From: FNAL::JBS 11-NOV-1991 23:23:45.26
To: FNAL::ORRIS
CC: MYSELF
Subj: Long 50 mm magnet inductance

I have done the following exercise with the data from DCA311.QB007 and find the following:

(Idot coil) / (dIshunt/dt)

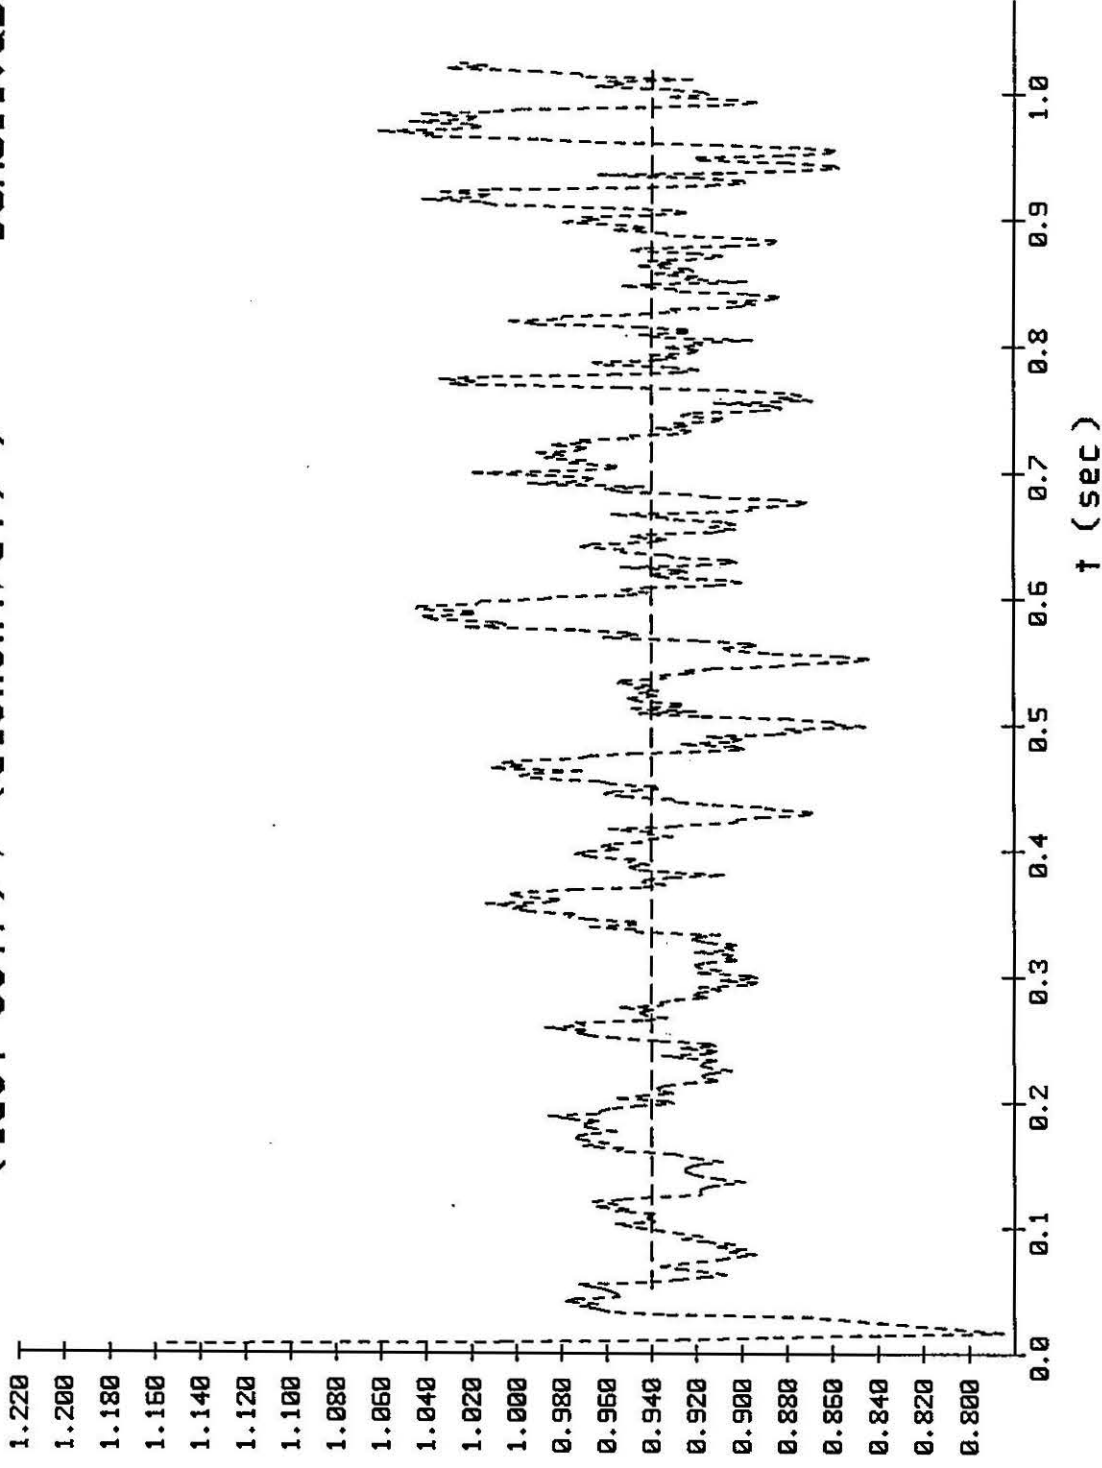
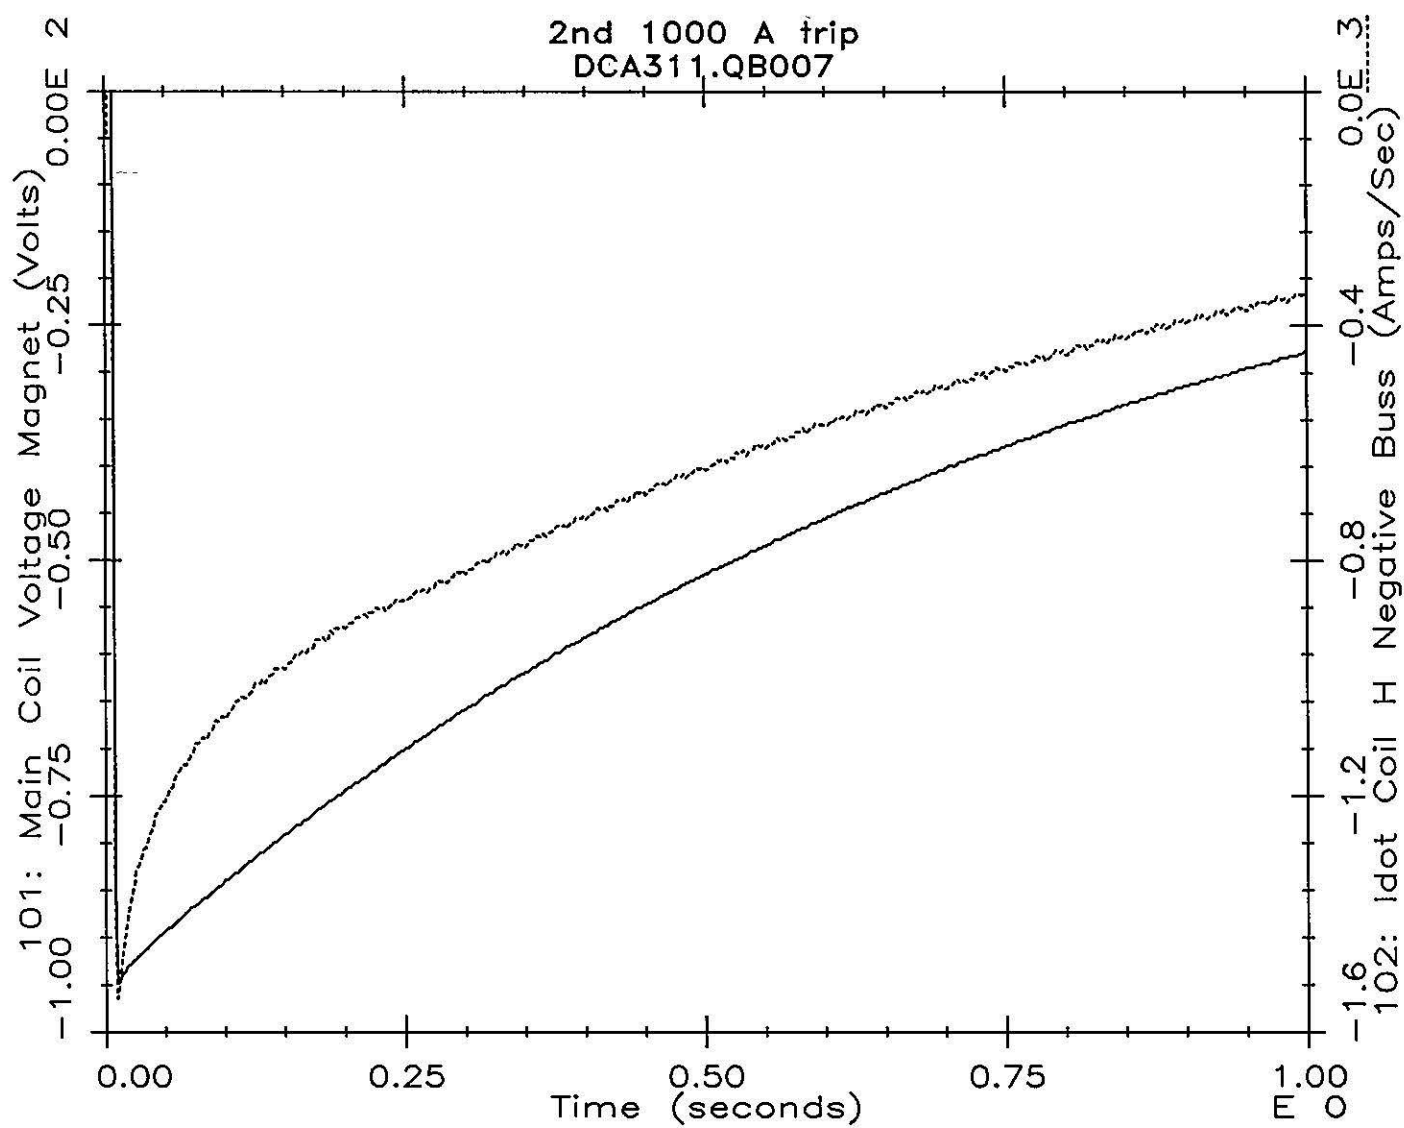
- 1) The inductance loaded for the Idot coil appears to be off by about 6%. That is, the dI/dt reported by the Idot coil is 94% of that deduced by differentiating the shunt signal. I tend to believe the shunt much more than the Idot coil, so I believe that it is the latter that has the wrong constants. I also believe that I determined this at some point during my time testing 40 mm magnets, but decided not to do anything about it so as to keep consistency through the whole set of data. Perhaps this should be fixed as we start 50 mm magnets.

$U(\text{Magnet}) / I \dot{t}$

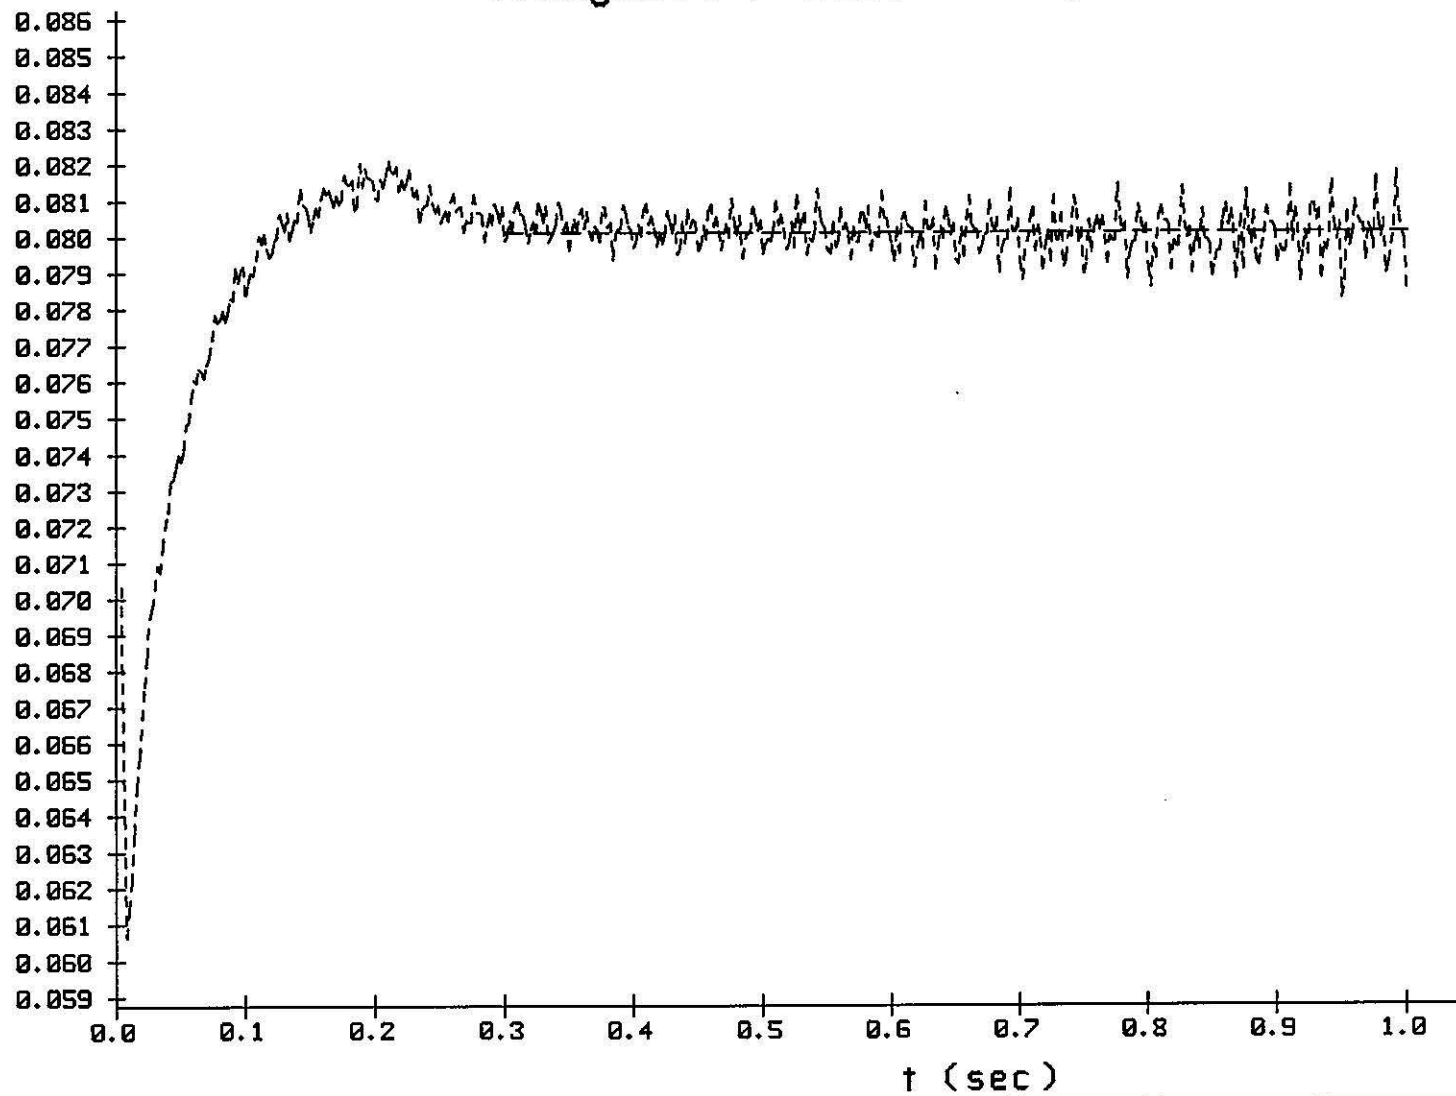
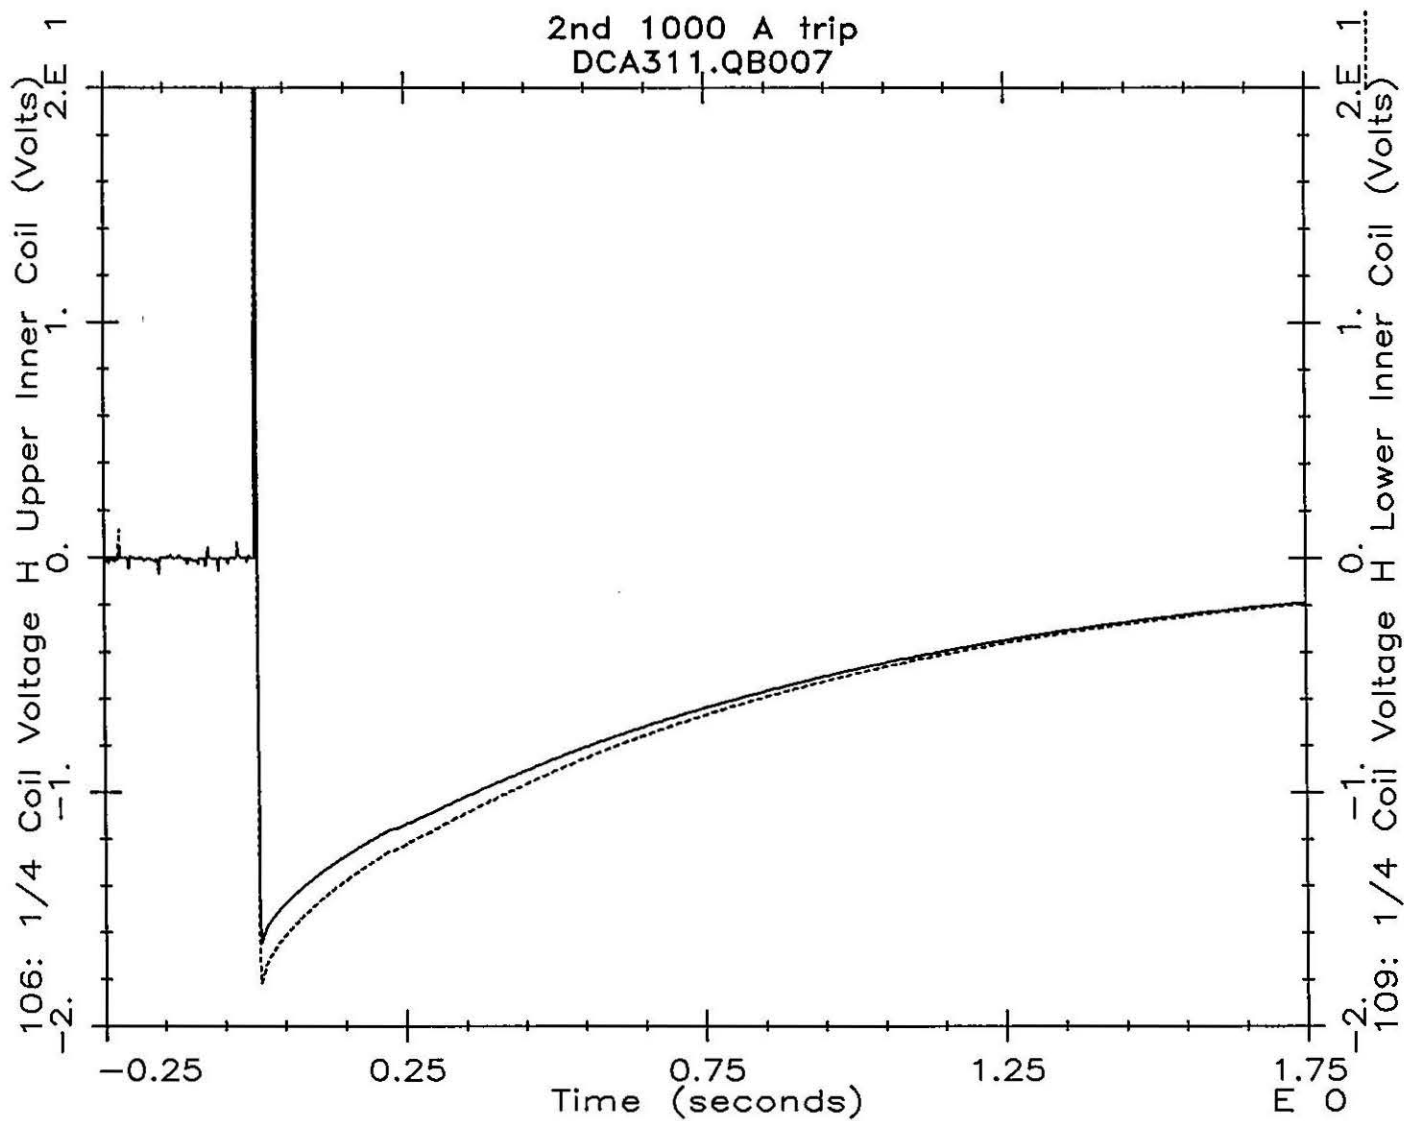
- 2) The ratio of the total magnet voltage to the dI/dt reported by the Idot coil is, for $0.3 < t < 1.0$ sec, 80.1 mH. (Starting the average after 0.3 sec allows the magnet inductance to recover from the "trauma" of dump firing and stopping at 1 sec keeps us well away from "zero divide by zero.") Since the true dI/dt is 6% larger than that used in this calculation, the true inductance is found to be 75.3 mH. This is just under 1% larger than that calculated by Ramesh Gupta who designed the cross section. The difference is, I would guess, within the uncertainty of the calibrations of the various isolation amplifiers.
